ADDENDUM #001

Date: 6/4/2026

Blair Community Schools
Arbor Park Elementary School
Addition and Renovation
1717 Adams Street, Blair, Nebraska 68008

JJA Project: 3670
Drawings & Specifications
Dated: 5/18/2026

1 AD1.1 DEMOLITION LEVEL ONE ENLARGED PLAN
3/16" = 1'-0"

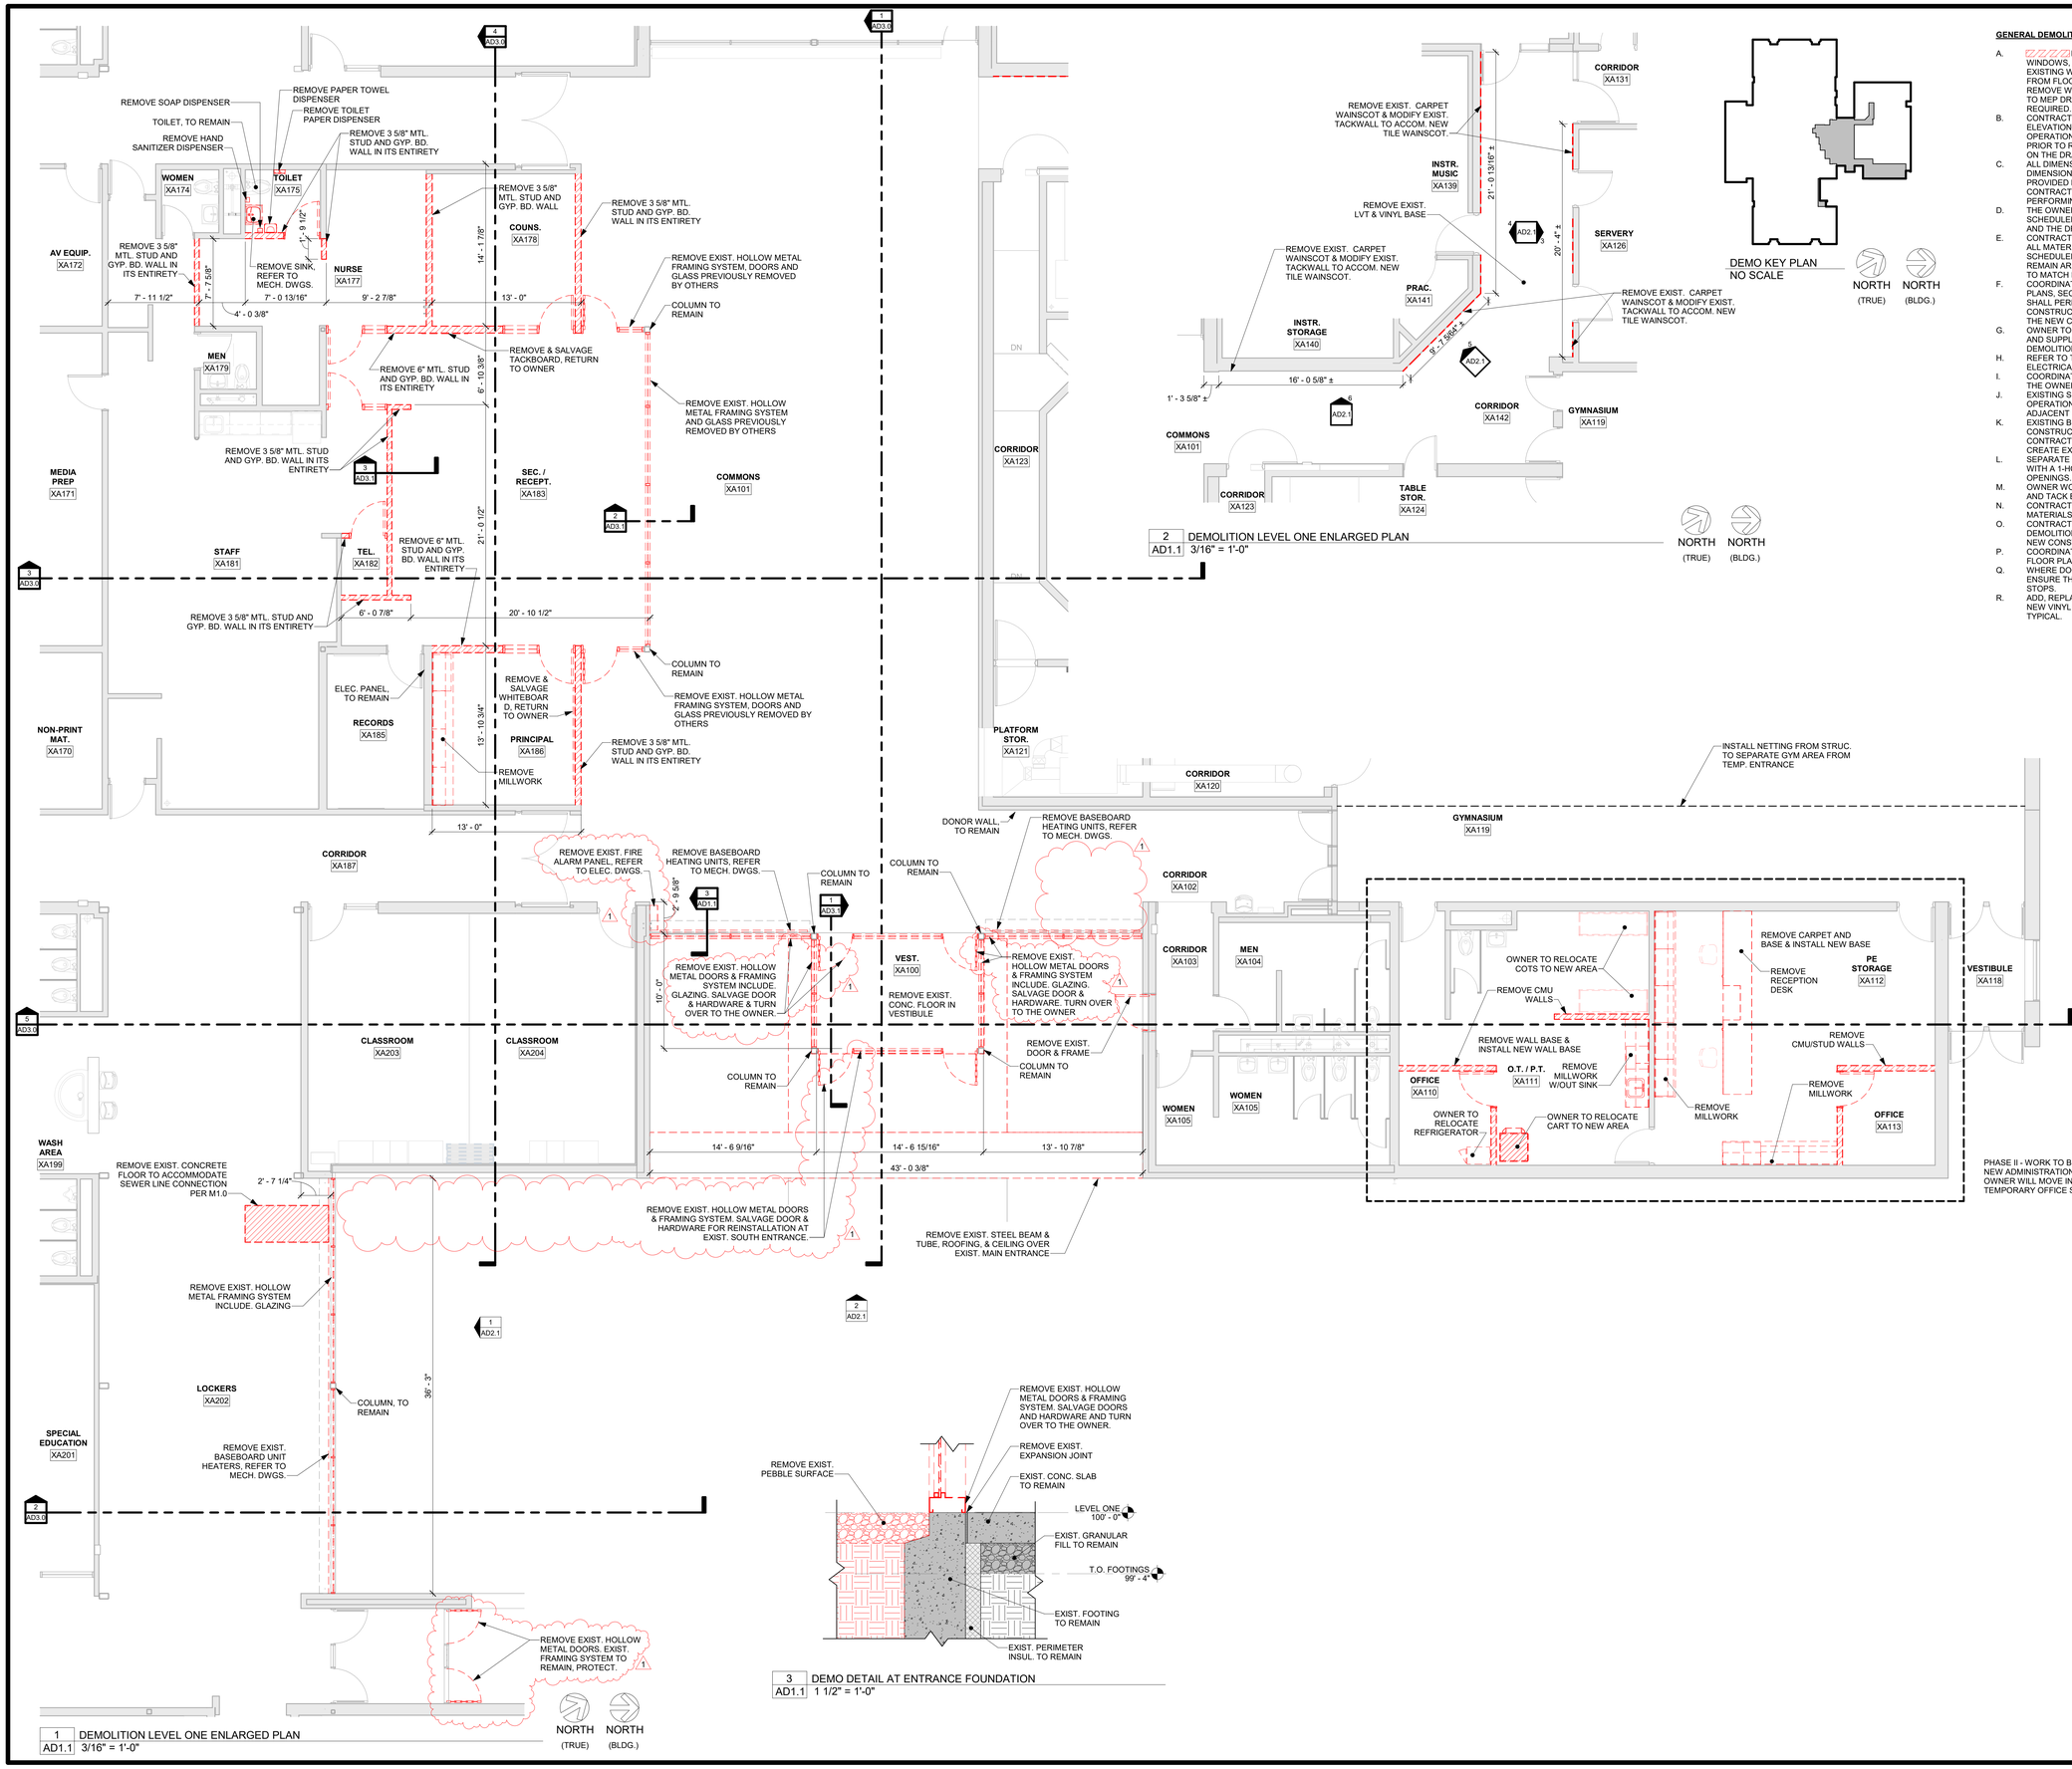
Item #11 Refer to Drawing AD1.1 – Demolition Floor Plan & Wall Sections and to the attached revised drawing sheet.

A. Refer to the revised 1/AD1.1 Demolition Level One Enlarged Plan.

1 DEMOLITION FLOOR FINISH PLAN
AD1.2 3/16" = 1'-0"

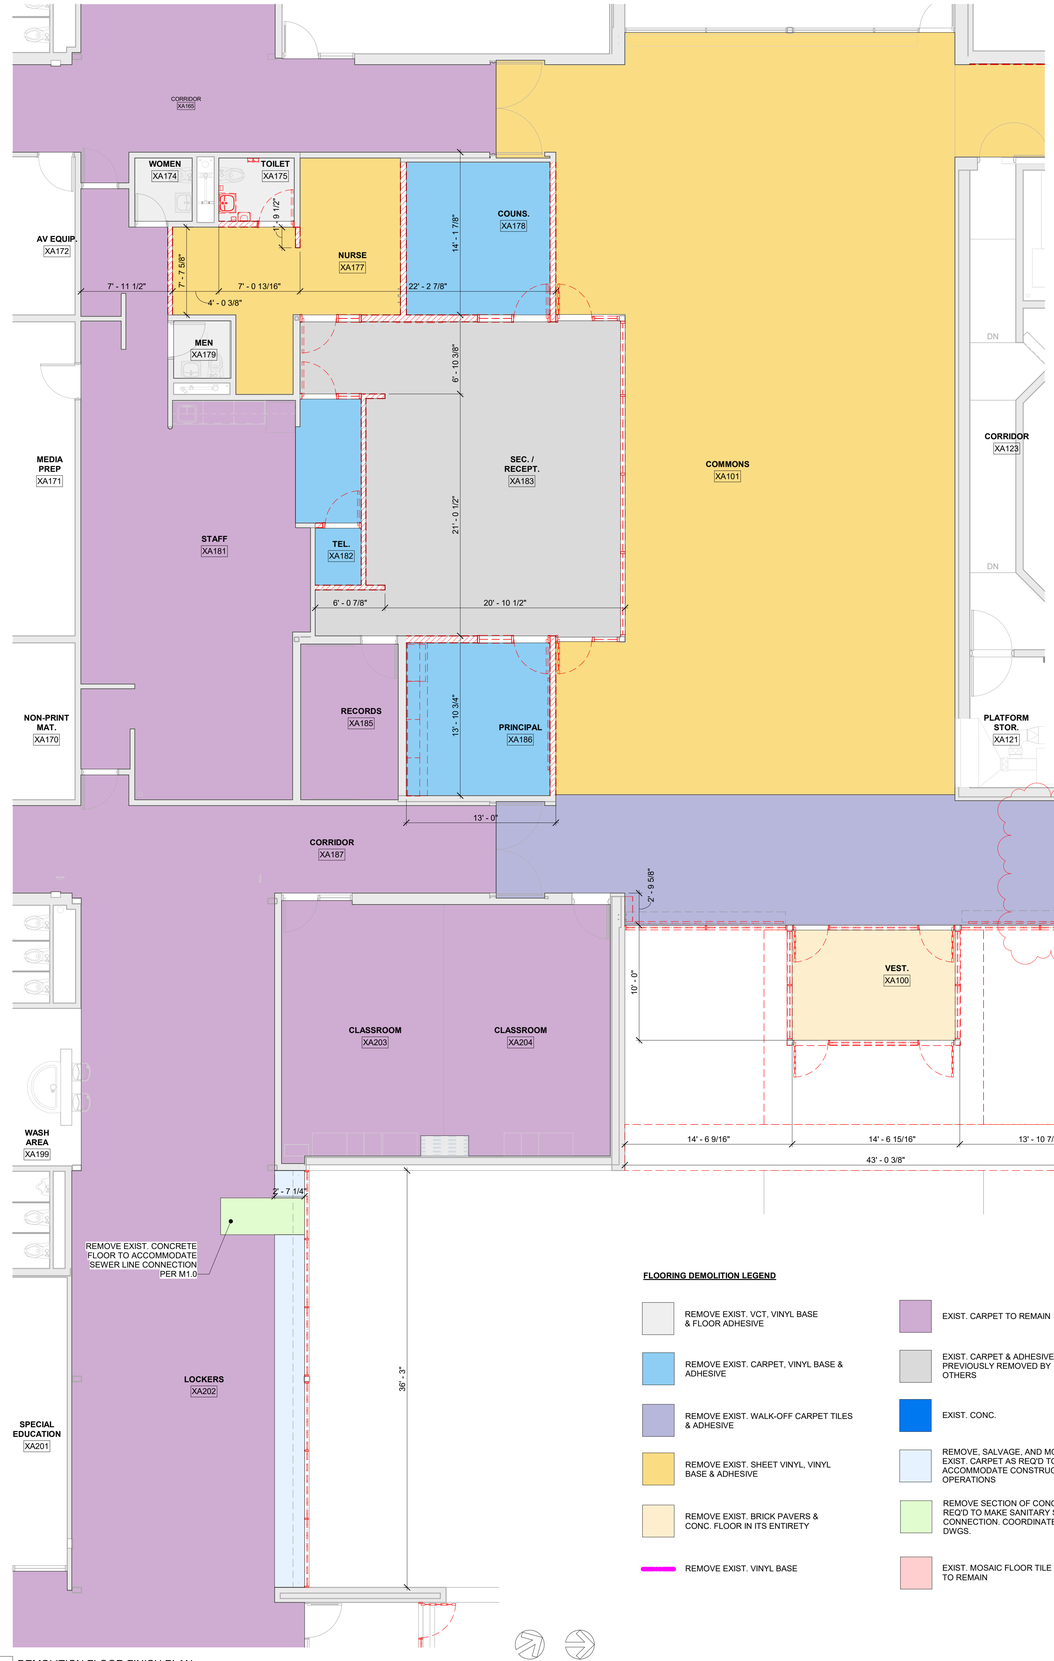
Item #12 Refer to Drawing AD1.2 – Demolition Finish Floor Plan and the attached revised drawing sheet.

A. Refer to the revised 1/AD1.2 Demolition Floor Finish Plan.

1 AD1.3 DEMOLITION LEVEL ONE REFLECTED CEILING PLAN
3/16" = 1'-0"

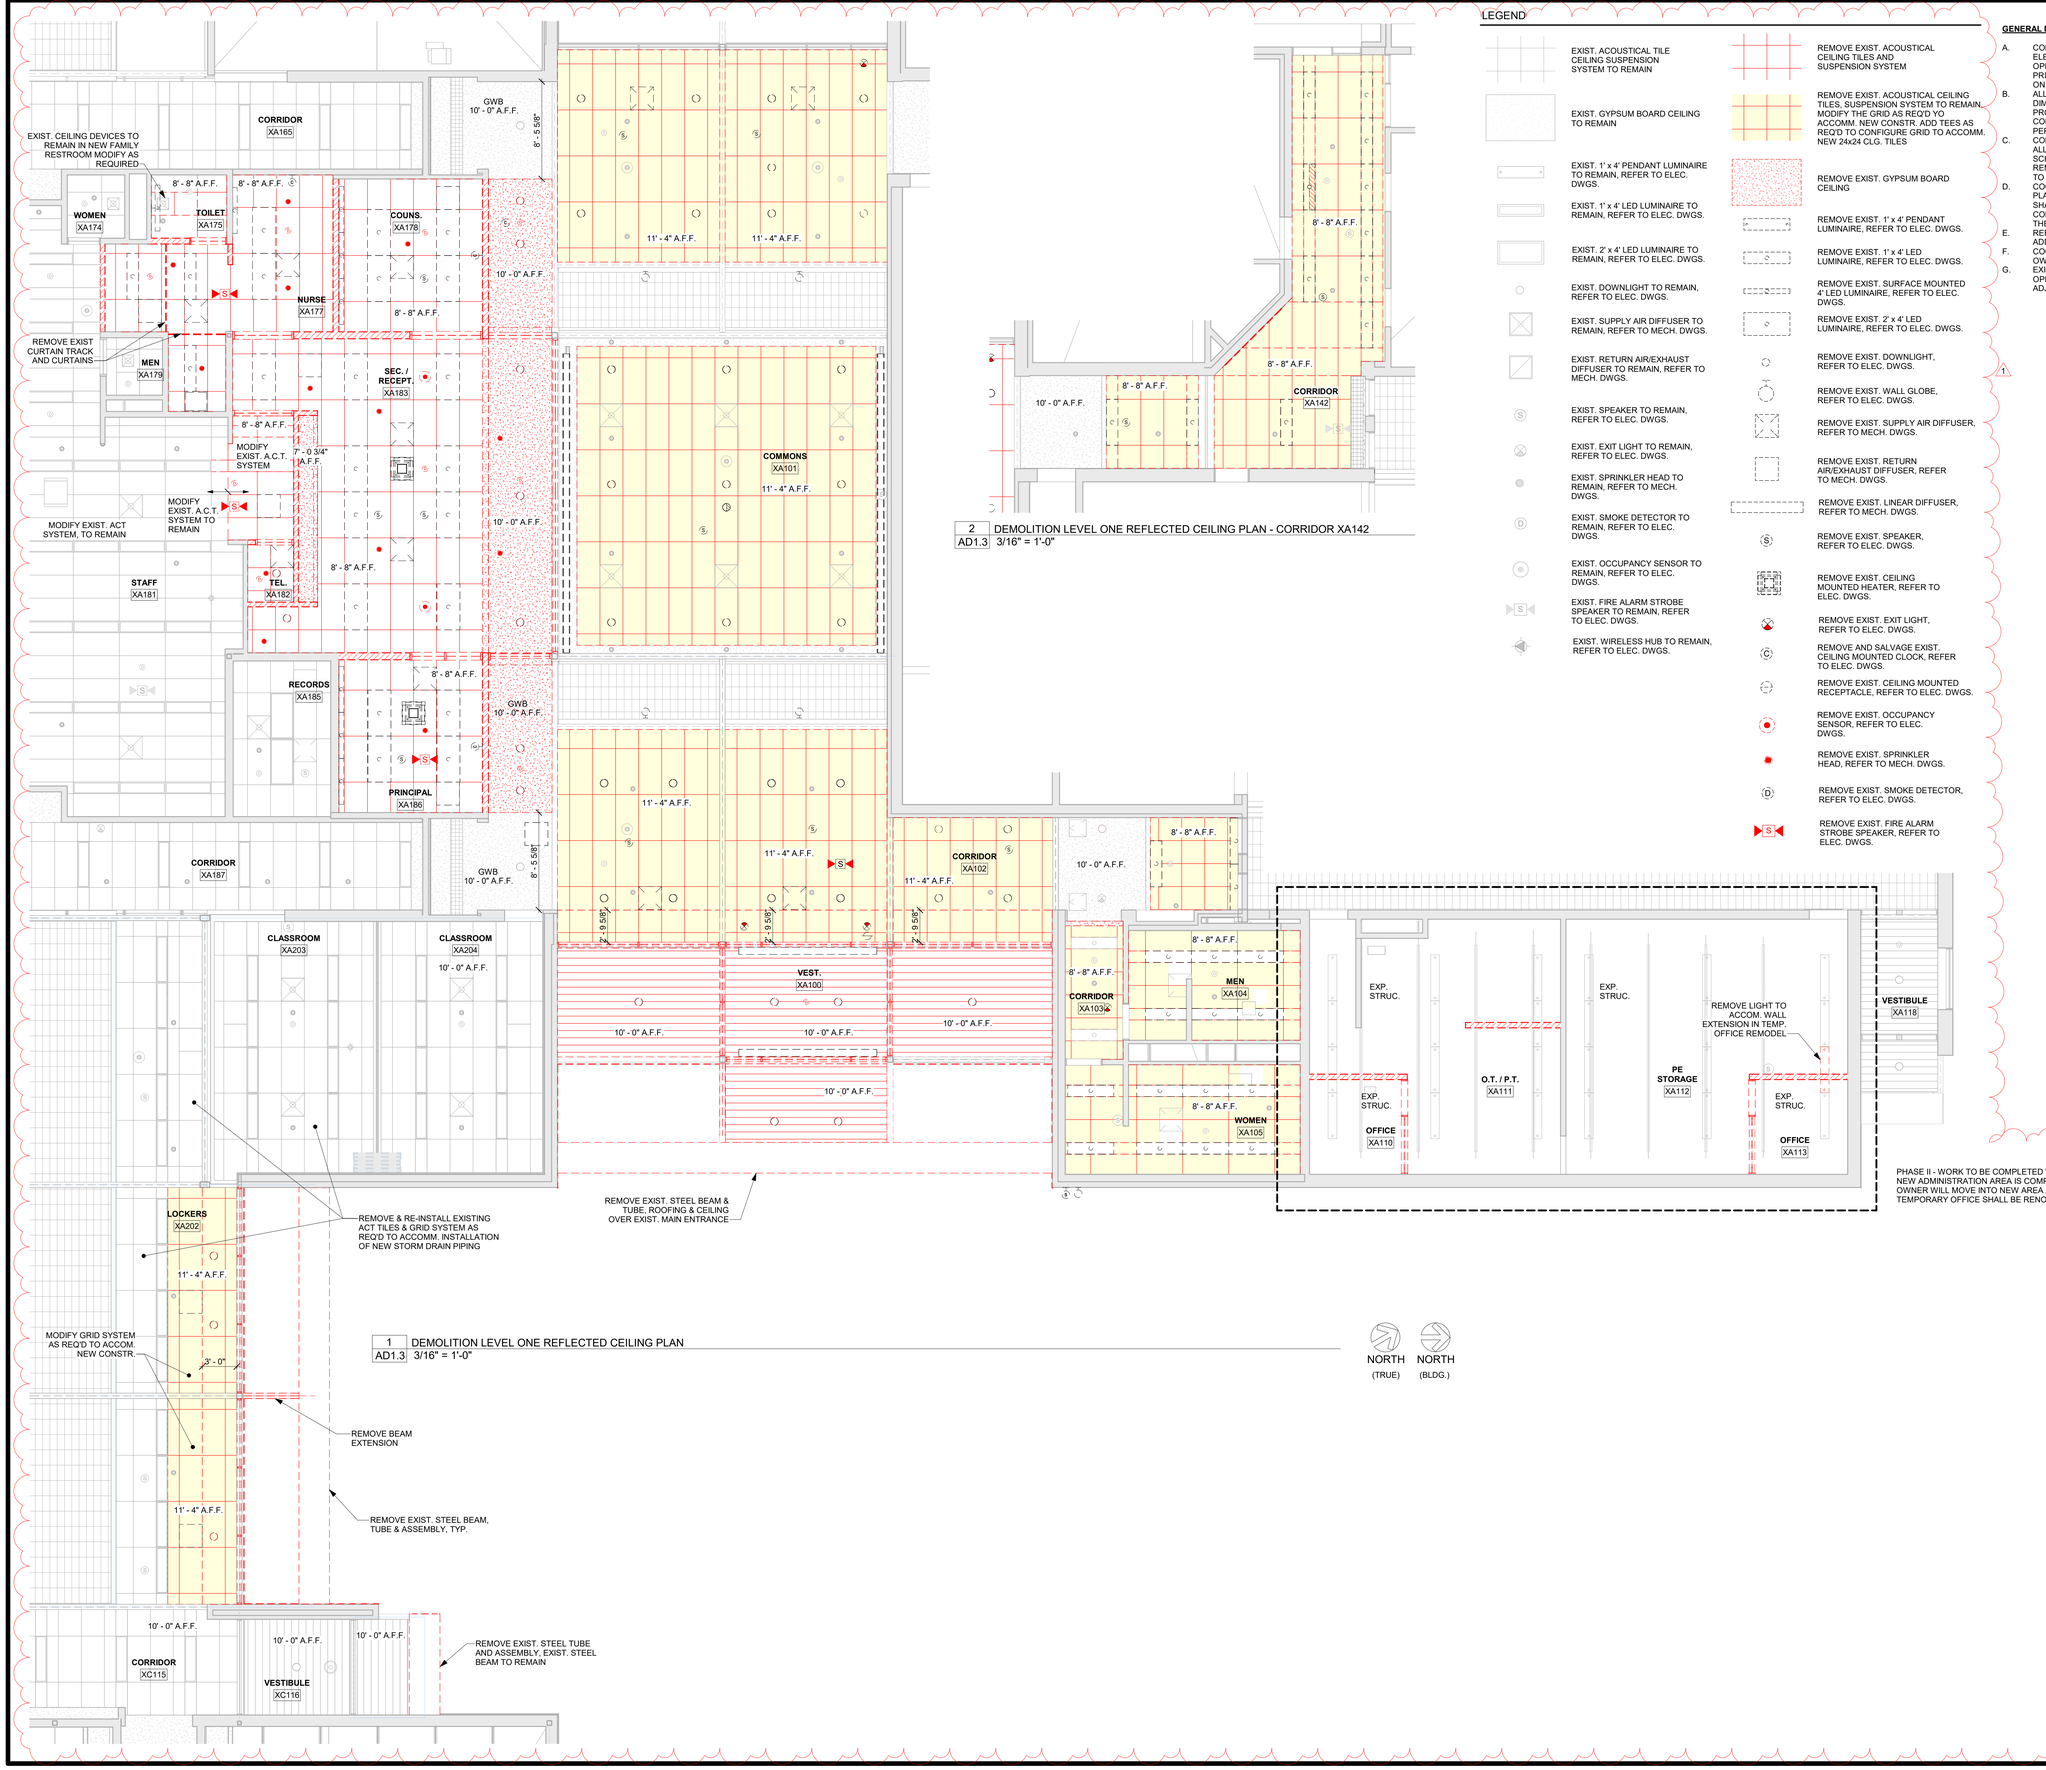
Item #13 Refer to Drawing AD1.3 – Demolition Reflected Ceiling Plan and the attached revised drawing sheet.

A. Refer to the revised 1/AD1.3 Demolition Level One Reflected Ceiling Plan.
B. Refer to the revised 2/AD1.3 Demolition Level One Reflected Ceiling Plan – Corridor XA142.
C. Refer to the revised Legend.

3 DEMO ROOF DETAIL
AD1.4 1 1/2" = 1'-0"

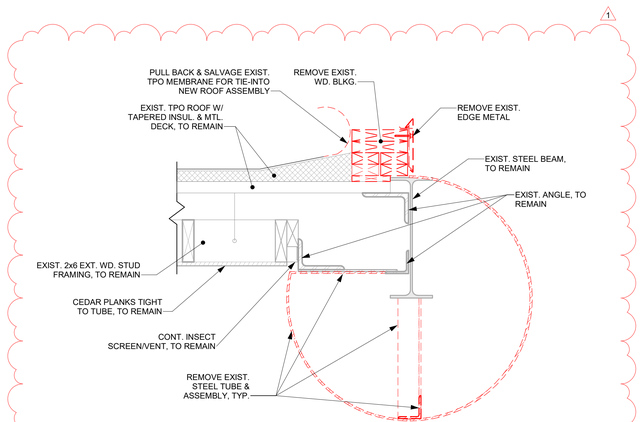
Item #14 Refer to Drawing AD1.4 – Demolition Roof Plan and Details and the attached revised drawing sheet.

A. Refer to the revised 3/AD1.4 Demo Roof Detail.

1 DEMOLITION SOUTH ELEVATION @ MAIN ENTRY
AD2.1 3/16" = 1'-0"

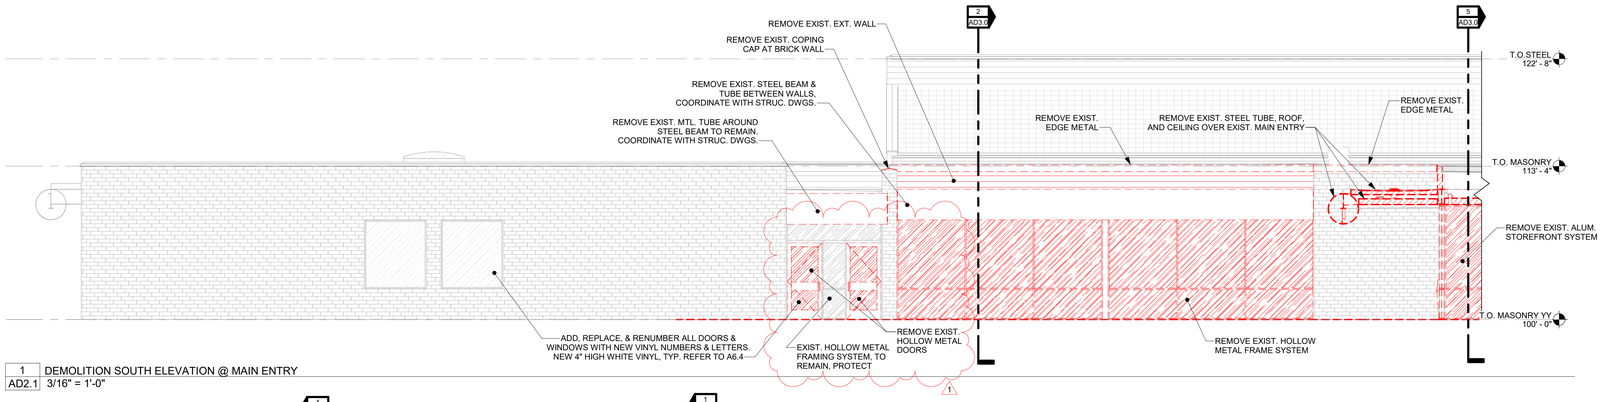
Item #15 Refer to Drawing AD2.1 – Demolition Interior and Exterior Elevations and the attached revised drawing sheet.

A. Refer to the revised 1/AD2.1 Demolition South Elevation @ Main Entry.
B. Refer to the revised 4/AD2.1 Corridor XA142 – Demolition South Wall.

1 AD3.0 DEMOLITION BUILDING CROSS SECTION EAST-WEST
1/8" = 1'-0"

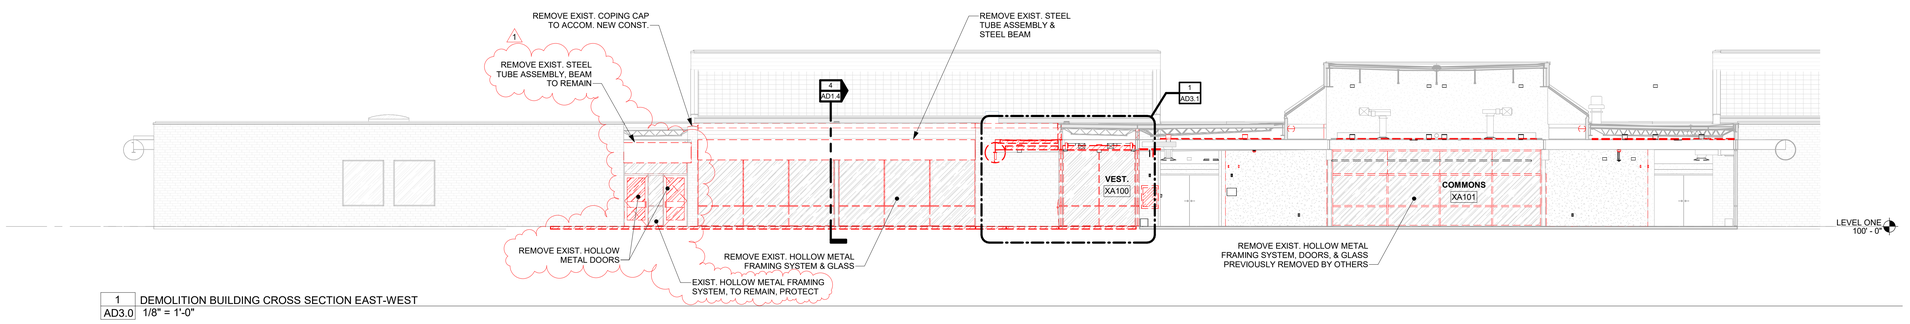
Item #16 Refer to Drawing AD3.0 – Demolition Building Cross Section and the attached revised drawing sheet.
A. Refer to the revised 1/AD3.0 Demolition Building Cross Section East-West.
